# Engineering Change Notification

Product Change of Silencer UC  
Sizes 1/8 and 1/4

**Project No**  
204 164

Previous Version	Future Version
Fig. 1	Fig. 2

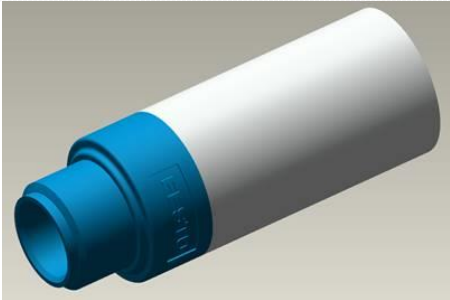
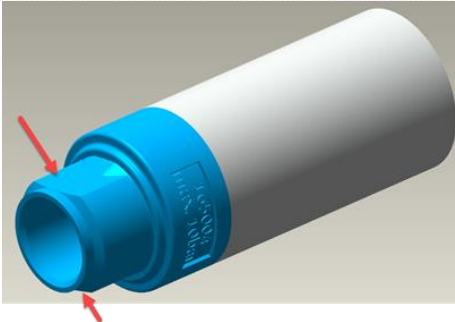
There is a small optical difference at the screw-in thread and in the coloring of the damper body between the "previous" and "future" version of silencers. But in the assembled state, no significant difference can be seen between the two versions. The product change has no impact on the technical data.
